Service Letter SL 34	DOA - No. EASA.21J.020
--	---------------------------------	---------------------------

MTV-9-B-S/198-58B installed on Cessna 182 (SMA - Application)

MTV-9-B-S propeller hub: A-926-2-()

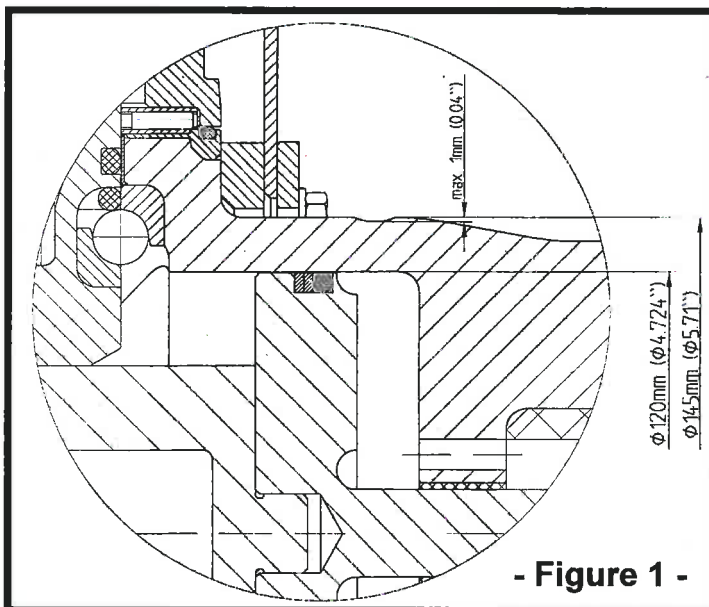
Improper clearances on the area of the propeller hub to the engine cowling which causes grinding marks on the propeller hub surface.

Measure the depth of the grinding mark according to Figure 1.

If the grinding mark does not exceed 1 mm (0,04 inch), the propeller may remain in service after in-field repair.

Carefully smoothen the affected area using abrasive paper or linen starting with grid number 200 and finish with grid number 400.

Protect the affected surface against corrosion with Alodine.
